SUBJECT: Closure of Melrose Ave between Melrose Place and Volunteer Blvd
MPC File # 8-D-15-SC; City Blocks 10482 and 10640

**Re: Right-of-Way Closure Request 8-D-15-SC
Block No. 10482 & 10640
CLT No. 108
Parcel No. 1**

File No. 8-D-15-SC Melrose Avenue (Gas)

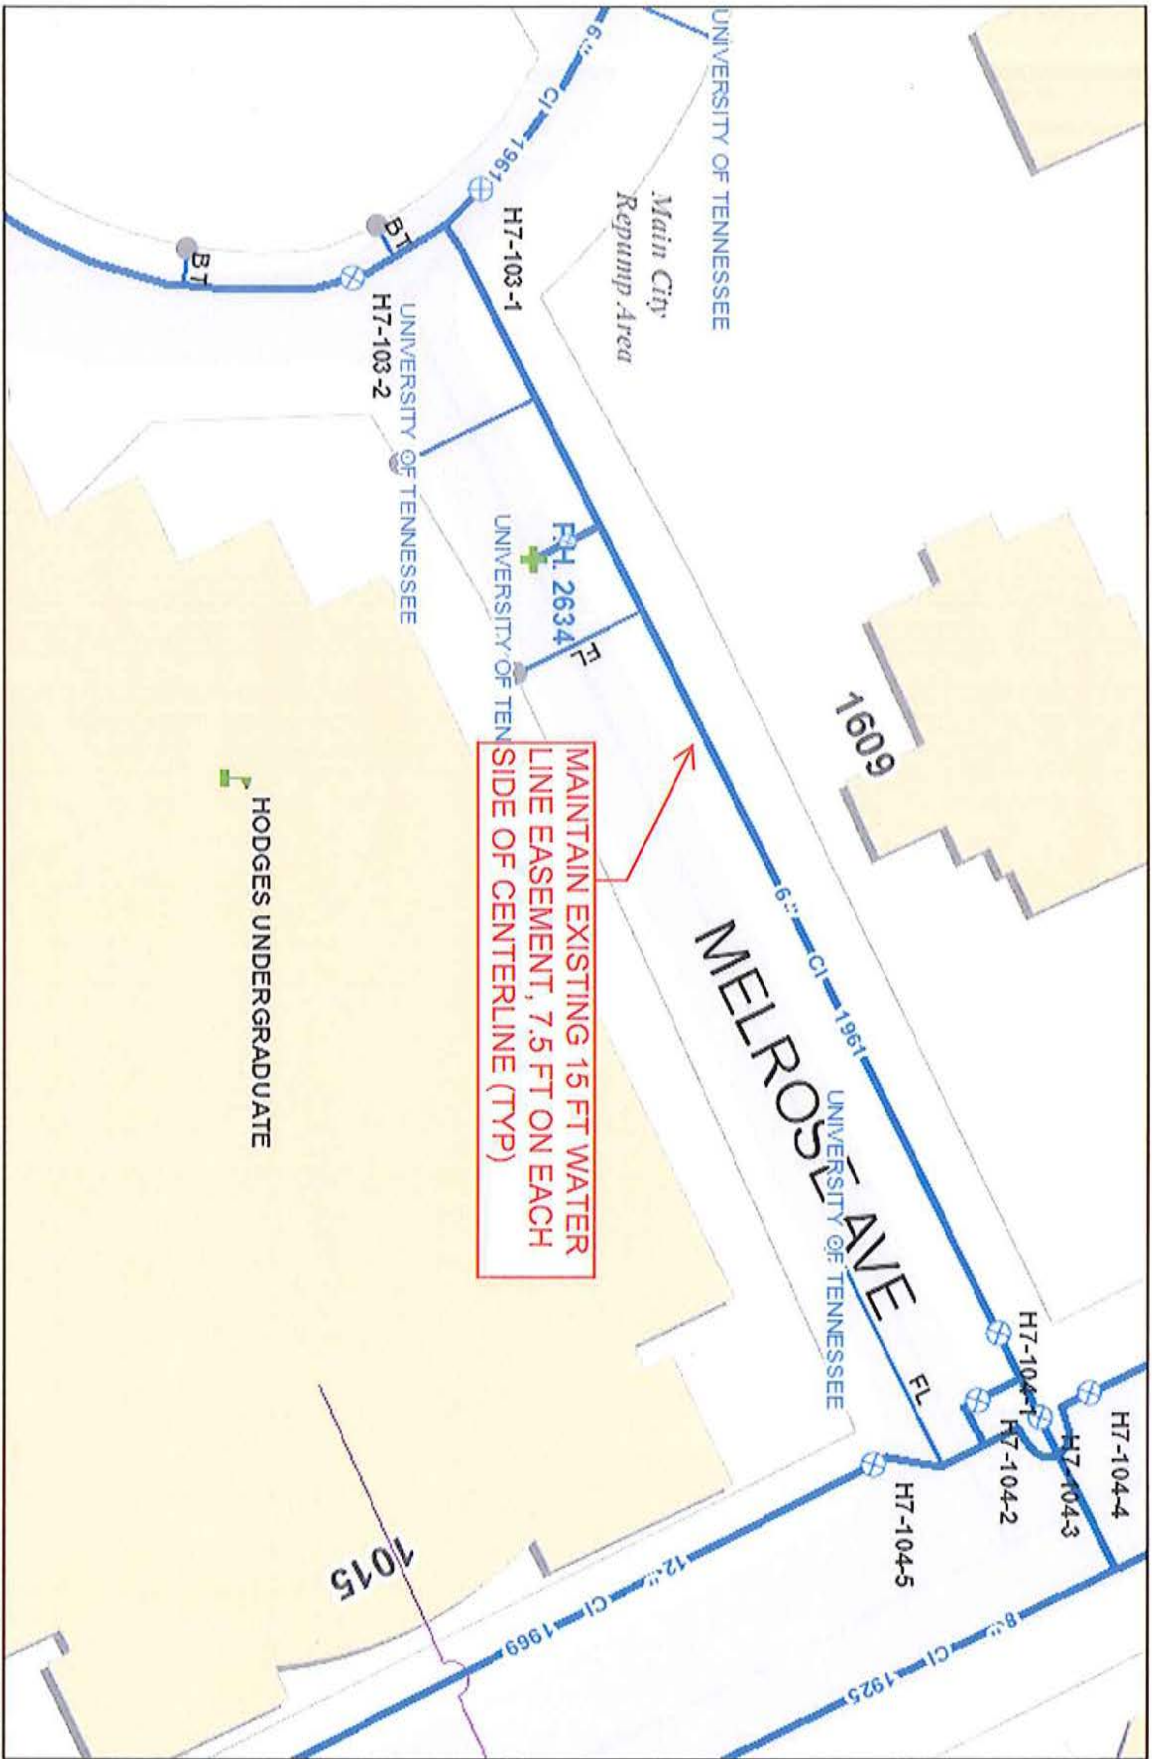
Gas – 7.5 feet on each side of the centerline of the gas line, 15 feet total width
Water – 7.5 feet on each side of the centerline of the water line, 15 feet total width

MAINTAIN EXISTING 15 FT GAS LINE EASEMENT, 7.5 FT ON EACH SIDE OF CENTERLINE (TYP)
